REMUDA RANCH

PRELIMINARY OVERALL AREA DEVELOPMENT PLAN

**CITY OF SAN ANTONIO
POADP APPLICATION**

POADP # 621

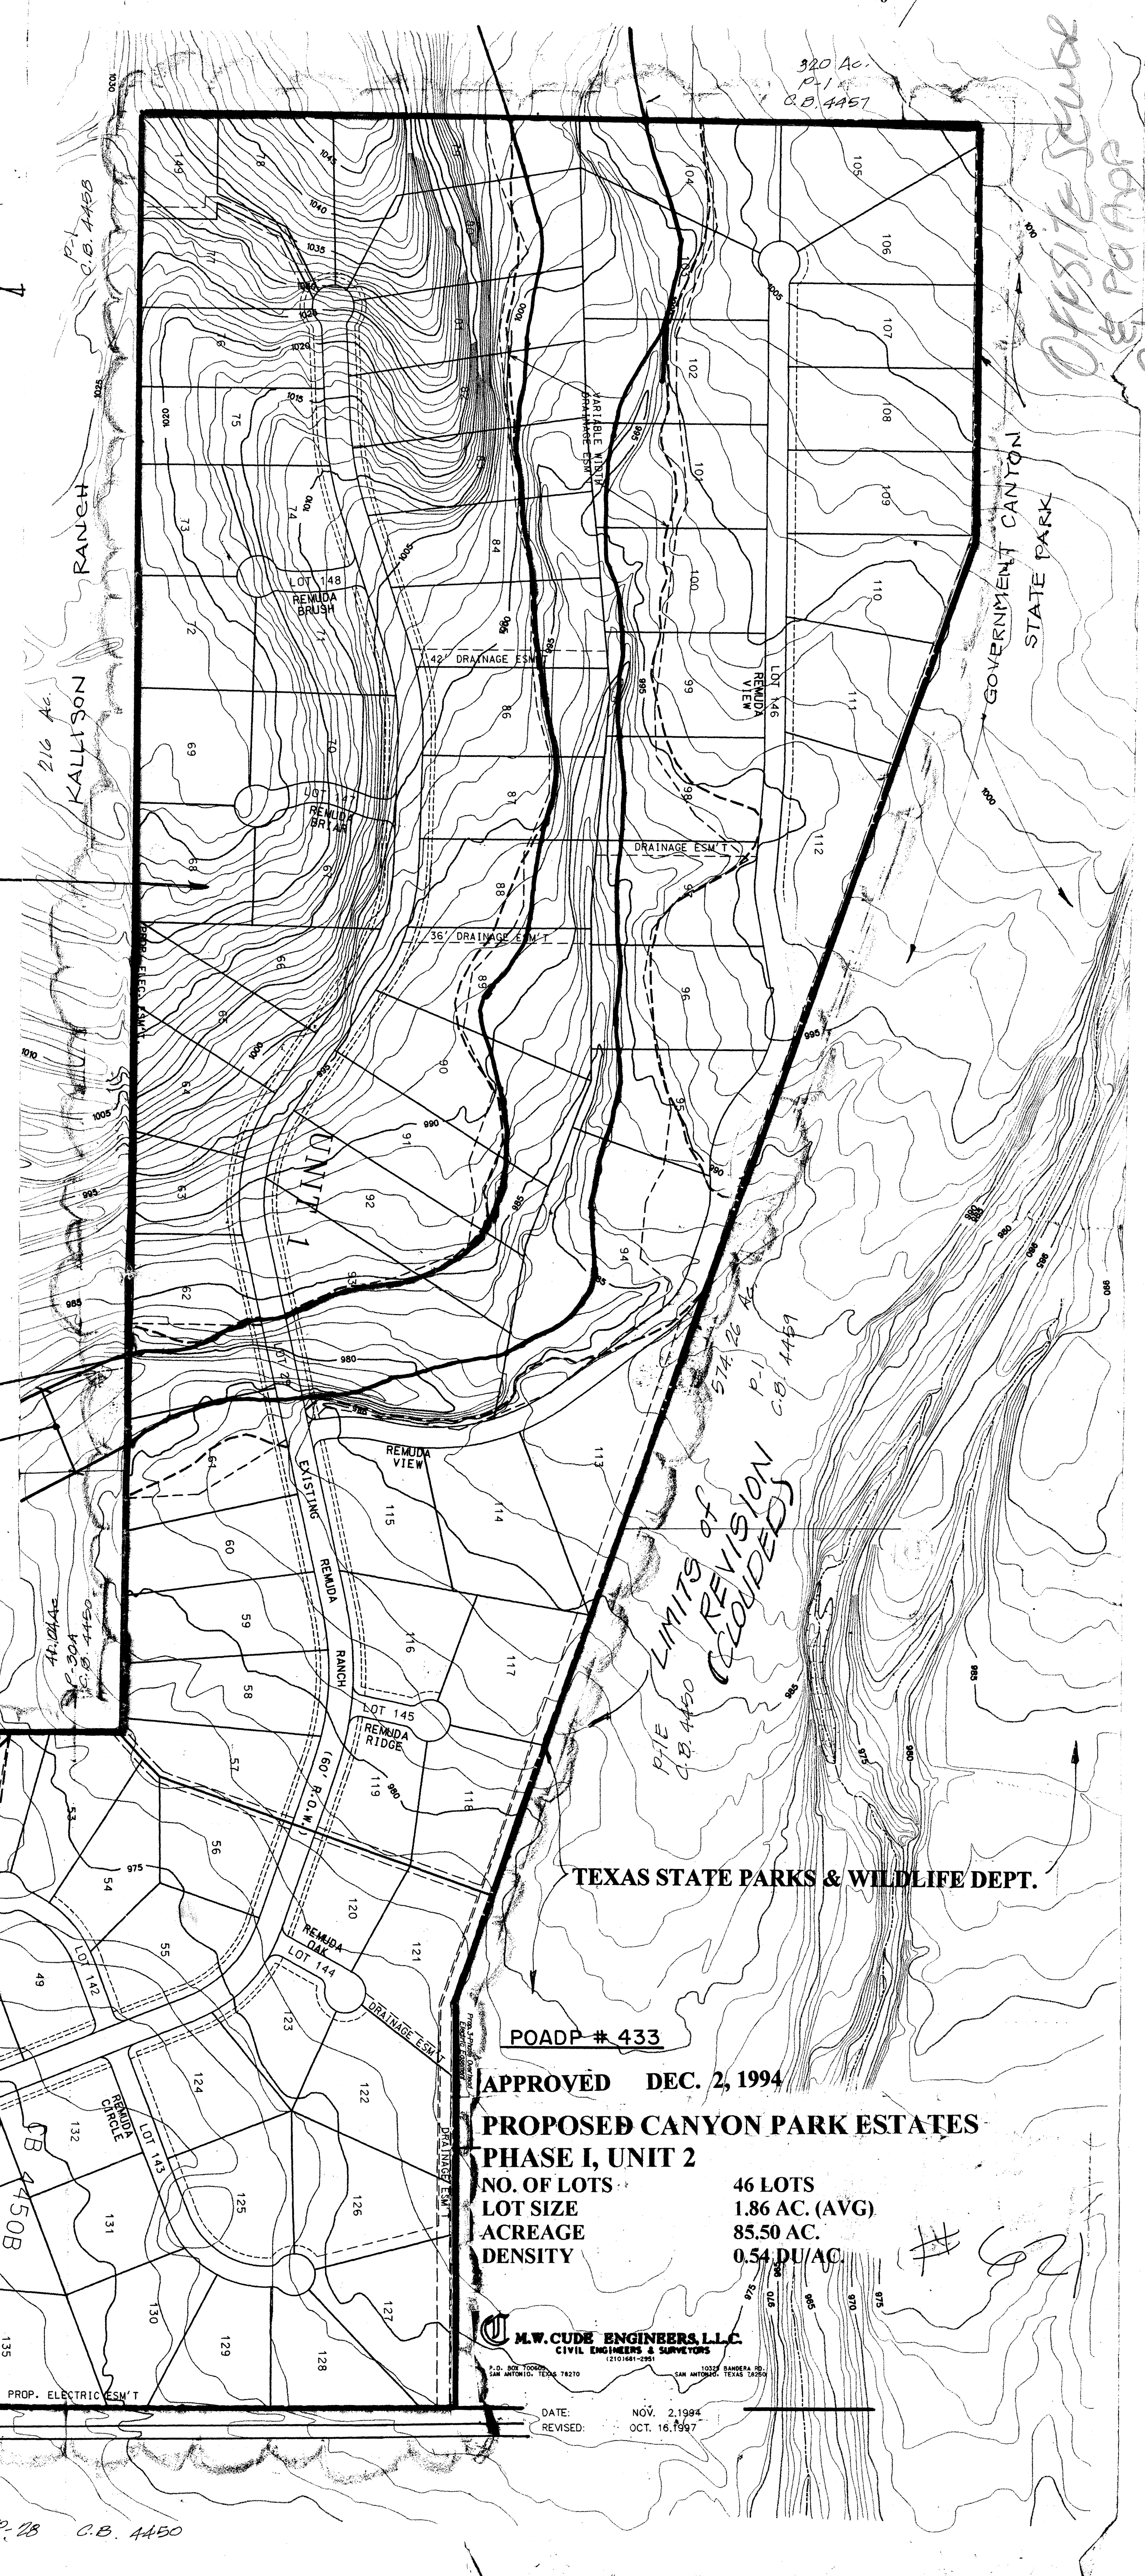
The City Staff Development Review Committee has reviewed Canyon Estates Subdivision Preliminary Overall Area Development Plan # 621. Please find enclosed a signed copy for your files. Although the northern portion of the plan was accepted, (the area bounded by the drain on the south, Government Canyon on the north, and Galm Road on the east) please note the following:

- Based on the topography, a Flood Plain Study and drainage review will probably be required during the platting process.
- This development will need to comply with tree preservation ordinance #85262. For information about these requirements you can contact Building Inspections at 207-7102.
- It will be expected that you will plat all of the property depicted in your POADP, to include: floodpains, drainage areas and open space.
- I would encourage you to work closely with the school district, so that they can plan accordingly.

- Clarify limits of POADP area and applicants ownership as well as abutting property ownership
- Cite need to comply with thoroughfare requirements Galm, FM 471 and east west thoroughfare. Limits of Government Canyon
- Cul de sac streets lengths greater than the minimum need to be addressed.

- need additional access points for unit 3
"still not addressed"
- please call Todd
- TIA
- trees
- drainage

- possibility of a bridge across the flood between the 2 long cul-de-sac
